# Wollongong Local Planning Panel Assessment Report | 13 October 2020

<b>WLPP No.</b>	Item 2
<b>DA No.</b>	DA-2019/1332
<b>Proposal</b>	Alterations and additions and use of premises as a light industry
<b>Property</b>	101 Auburn Street, Coniston
<b>Applicant</b>	MMJ Wollongong
<b>Responsible Team</b>	Development Assessment and Certification - City Wide Team (AS)

## ASSESSMENT REPORT AND RECOMMENDATION

**G-099**

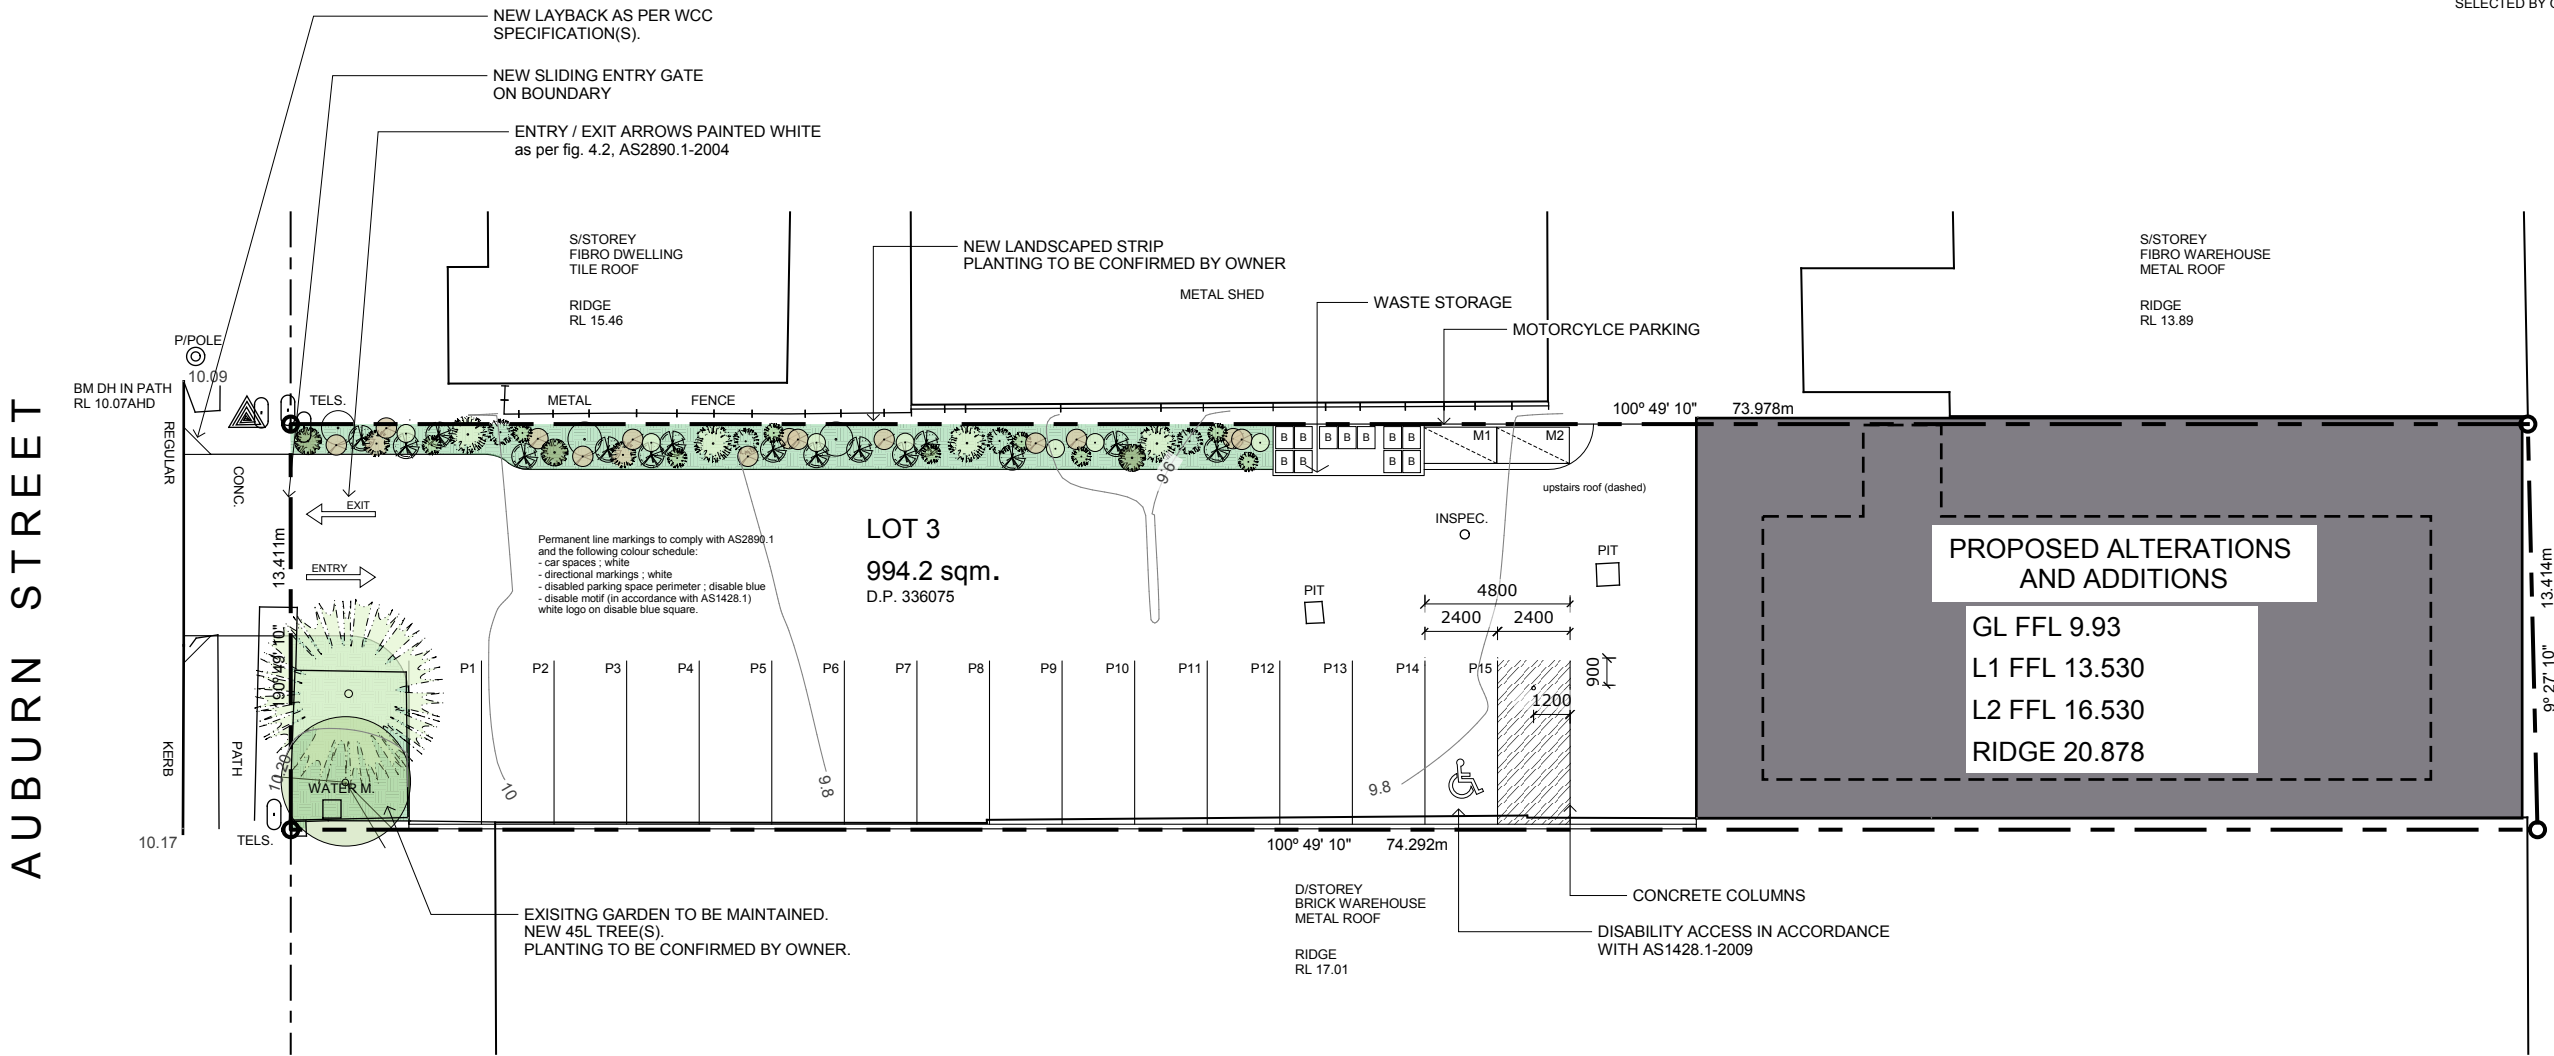
The proposal involves partial demolition of the building, as shown on demolition plan G-099. Conditions of consent are recommended regarding demolition practices and disposal of any asbestos materials.

Demolition of some building elements is proposed, as shown on the demolition plan (G-099) and existing floor plans (A-199). Conditions of consent are recommended requiring preparation of a demolition work plan, safe handling of asbestos and demolition notice to surrounding properties.

**G-100**

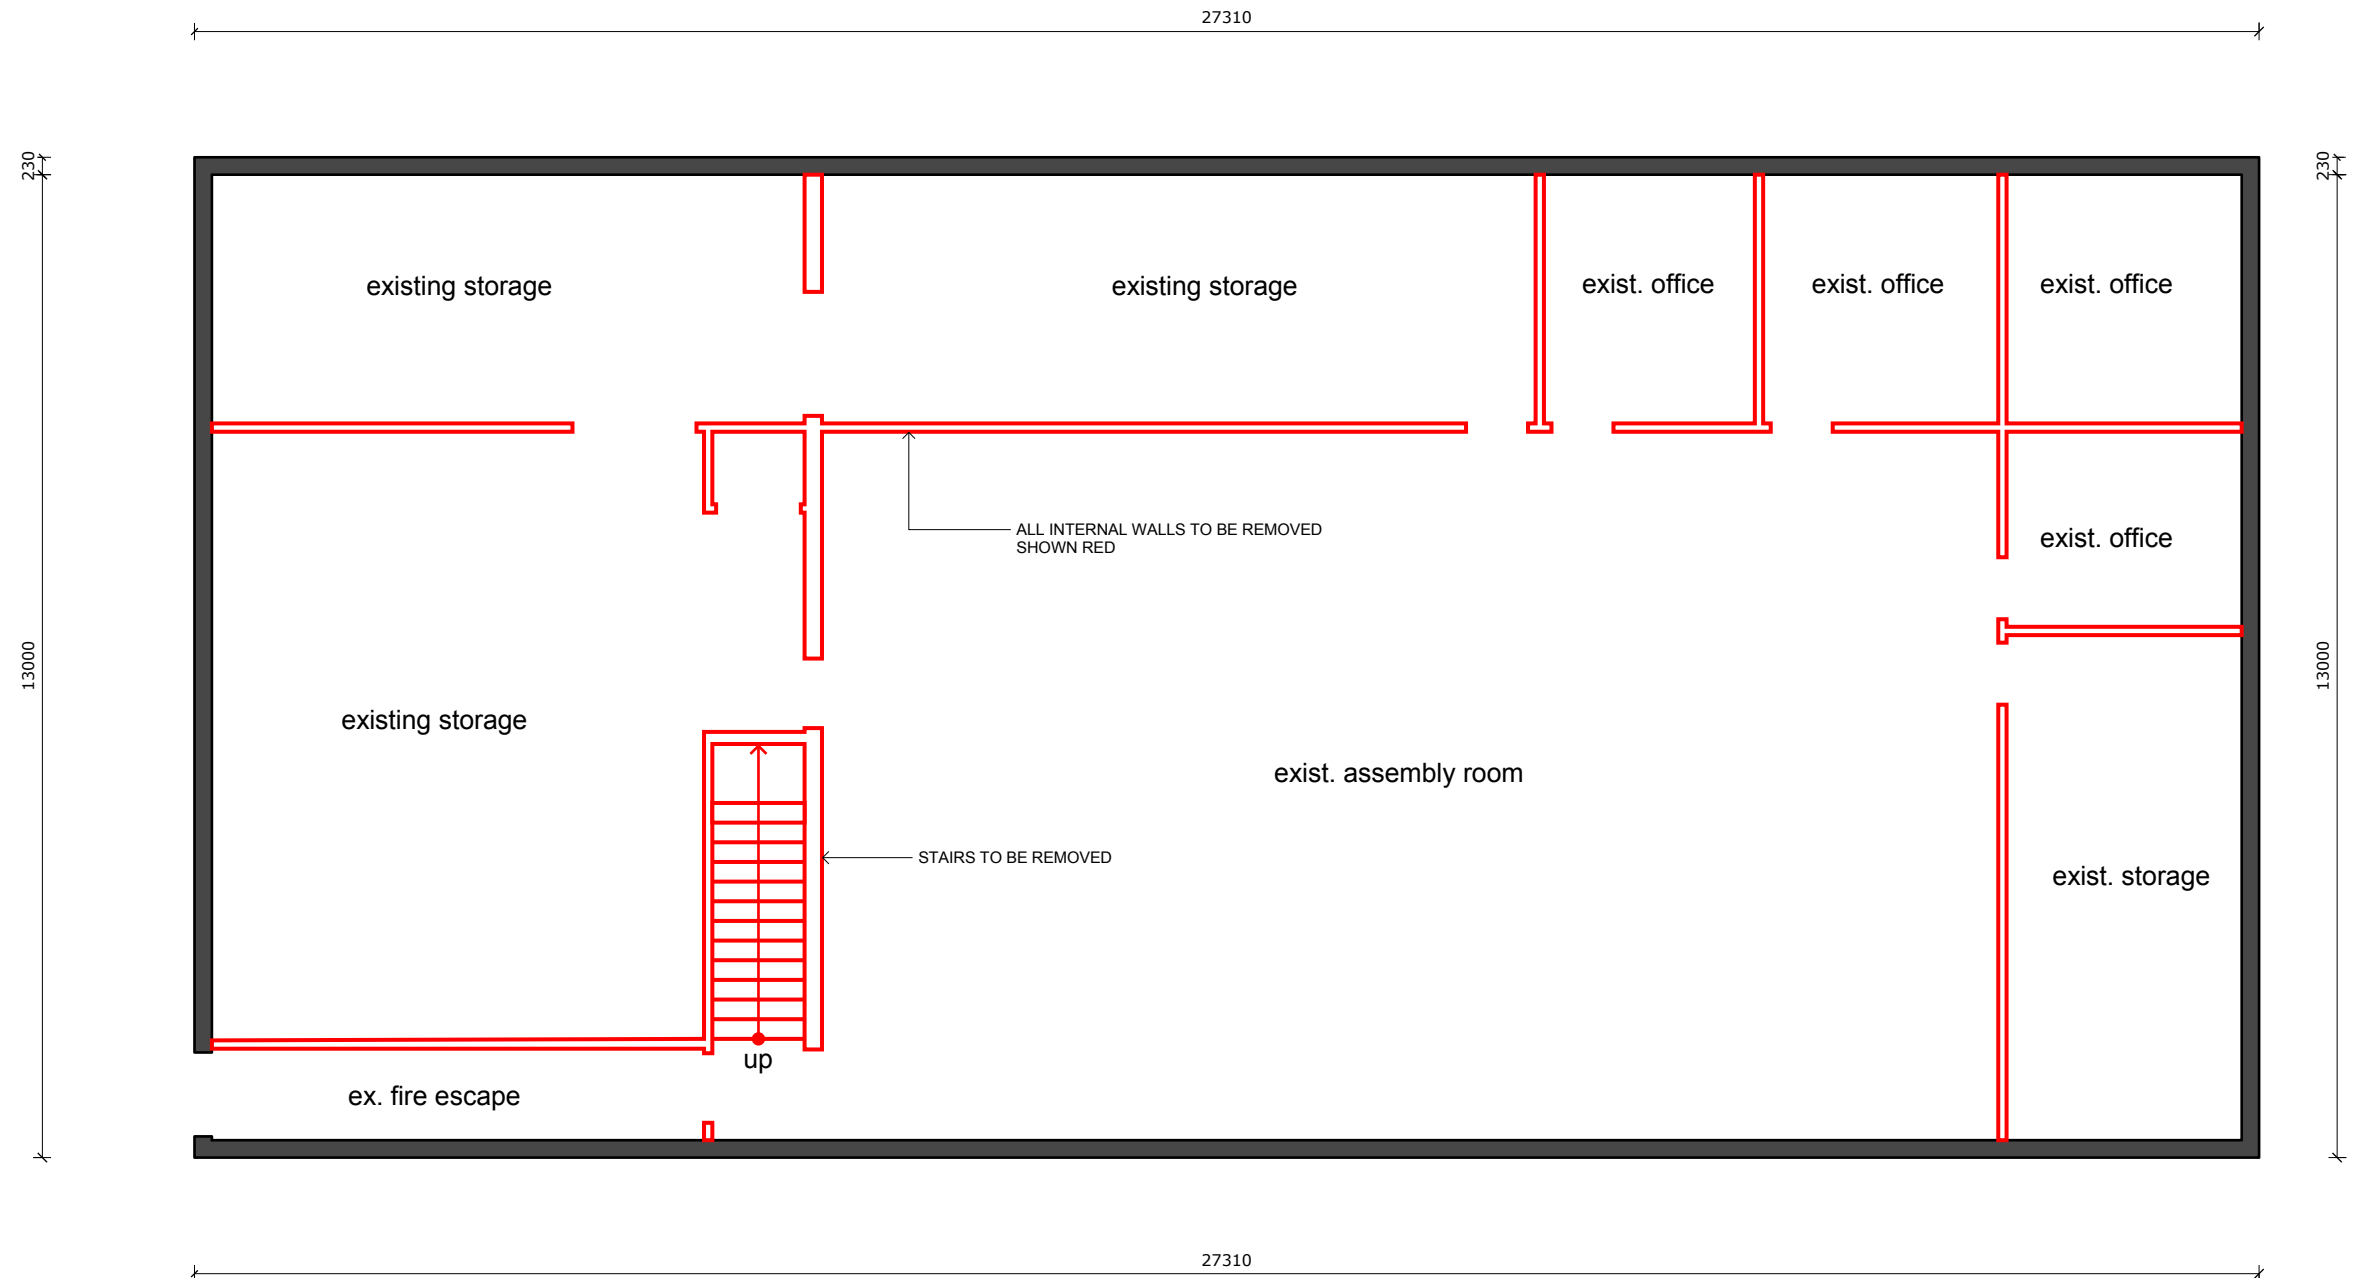
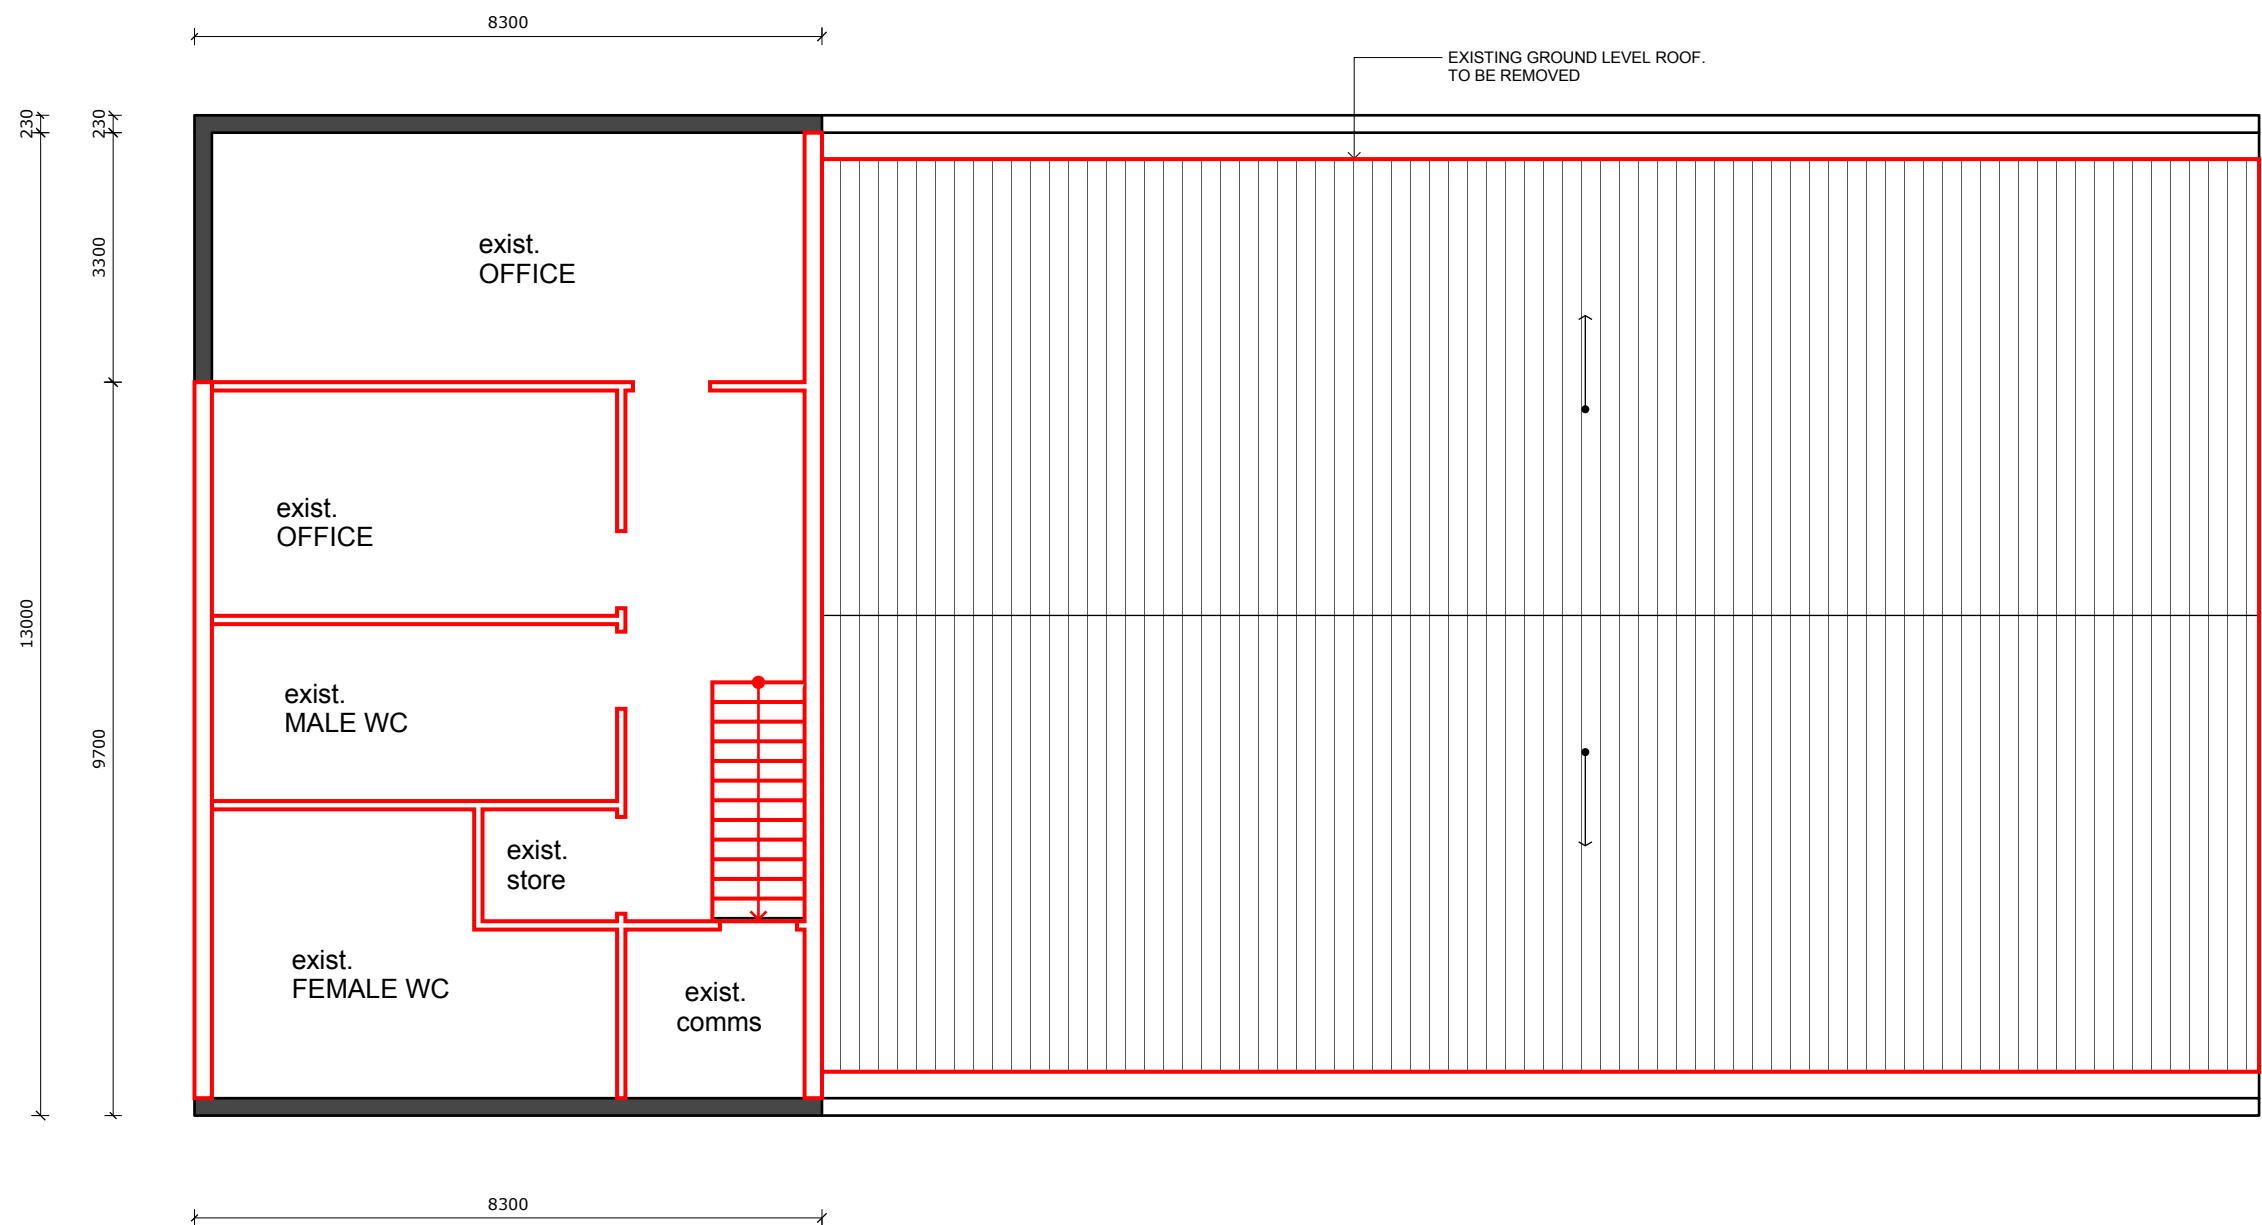
Council's officer also recommended the side landscape strip be relocated from north to south, to allow greater sunlight to the plantings. The applicant advised this would adversely impact on manoeuvring and access to the site and requested the existing northern landscape strip remain in place.

The current site plan G-100 now refers to 'planting to be confirmed by owner'.

Council's Traffic engineer has not raised any concerns subject to conditions of consent. Fifteen parking spaces are shown on the site plan, however it is recommended that one space is deleted to accommodate a canopy tree in the car park. The resulting 14 spaces would still exceed the minimum 10 spaces required for the development (1 space per 75m<sup>2</sup> for industrial development).

It is recommended that a condition of consent is applied requiring the landscape plan at Construction Certificate stage to show one canopy tree in the car park. This could be accommodated by replacing one car parking space, resulting in 14 spaces for the development which is more than the 10 required by WDCP 2009. Council's landscape officer also questioned the suitability of some species shown on the landscape plan, and therefore alternative species should be nominated on the final landscape plan.

**Note:** Applications should be made to Customer Connections – South Coast, Endeavour Energy PO Box 811 Seven Hills NSW 1730.
- 8) **Car Parking and Access**  
The development shall make provision for a total of 14 car parking spaces (including 1 car parking space for people with disabilities), 2 motorcycle parking spaces and 4 (Class B) employee bicycle spaces. This requirement shall be reflected on the Construction Certificate plans. Any change in above parking numbers shown on the approved DA plans shall be dealt with via a section 4.55 modification to the development. The approved car parking spaces shall be maintained to the satisfaction of Council, at all times.

**DESCRIPTION**  
North & East Elevation  
**PAGE SCALE**  
1 : 100  
**PAGE SIZE**  
A3  
**A-250**

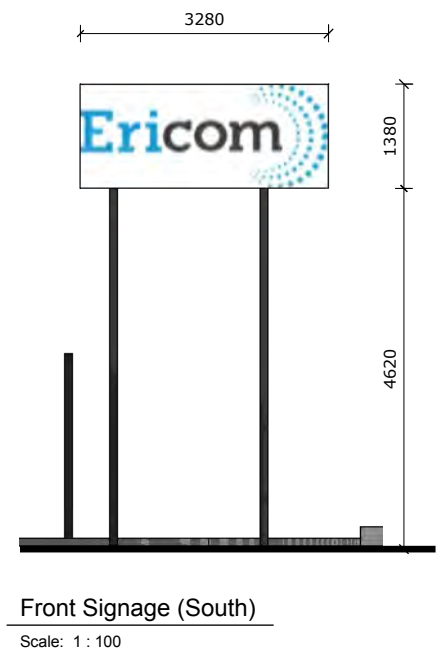
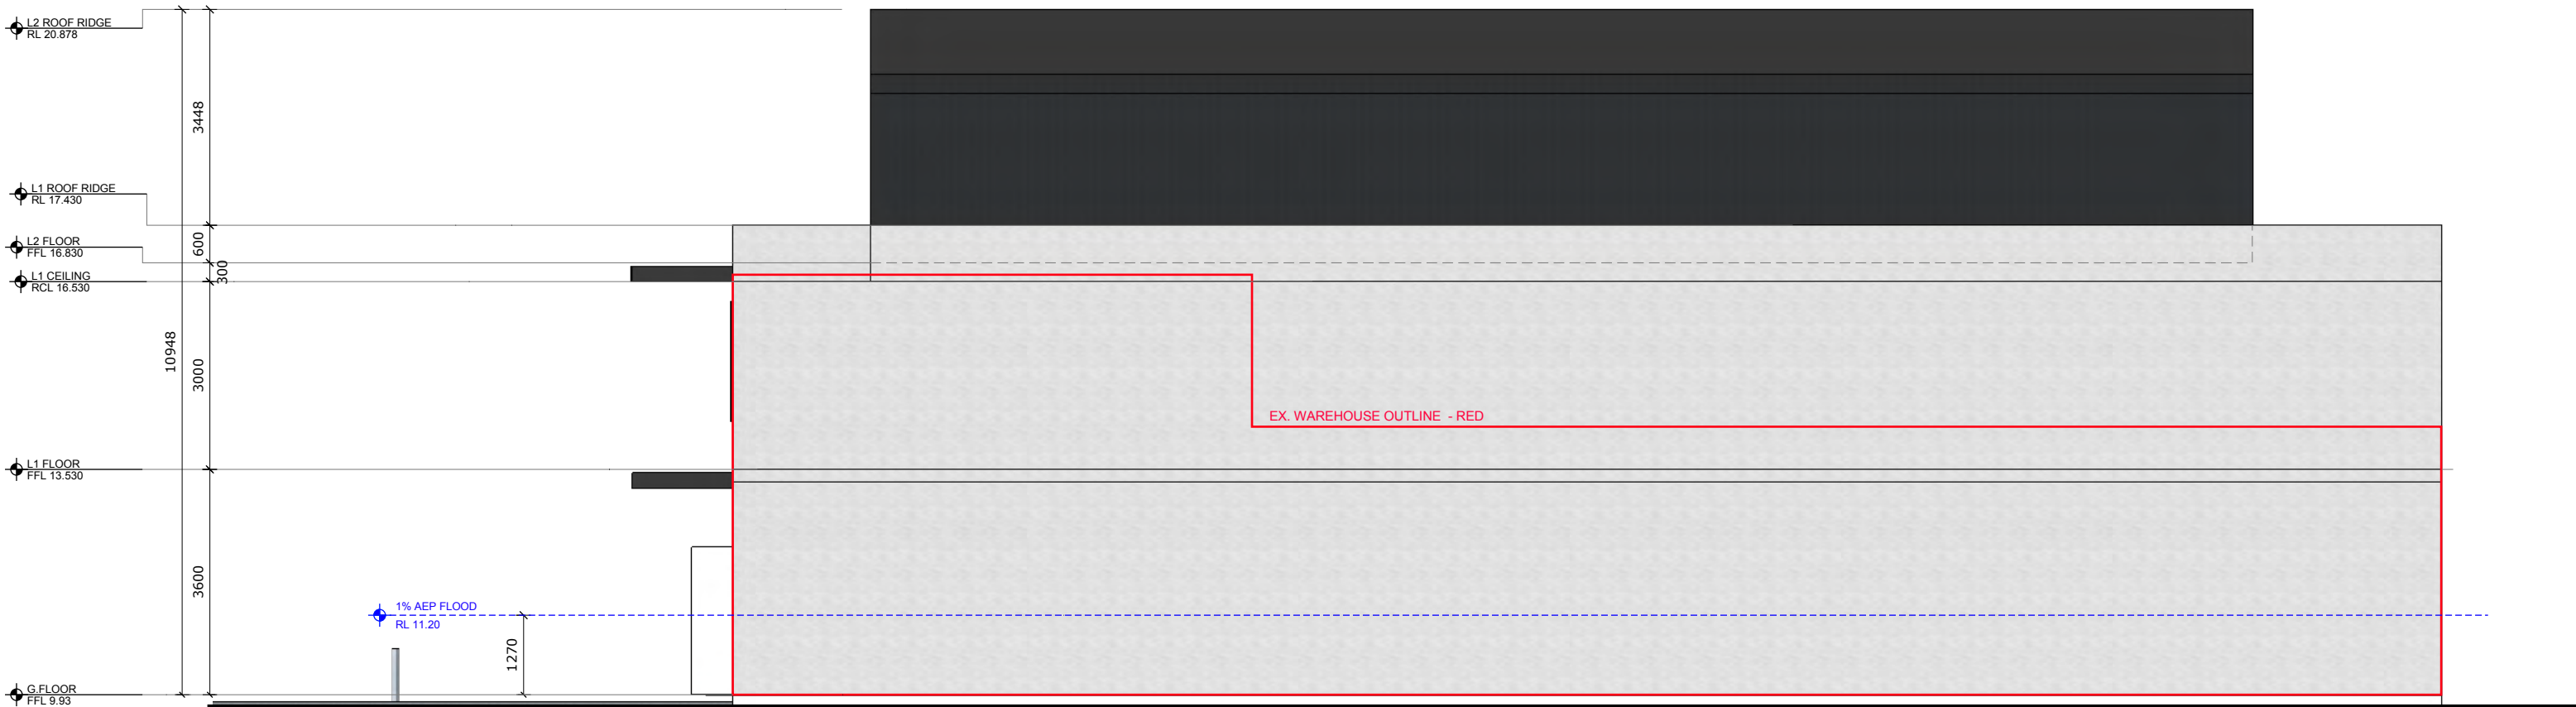
One freestanding pylon sign is proposed, as shown on plan A-250. The sign has dimensions 1.38m x 3.28m and an overall height of 6m. A fascia sign is also proposed, which is exempt development.
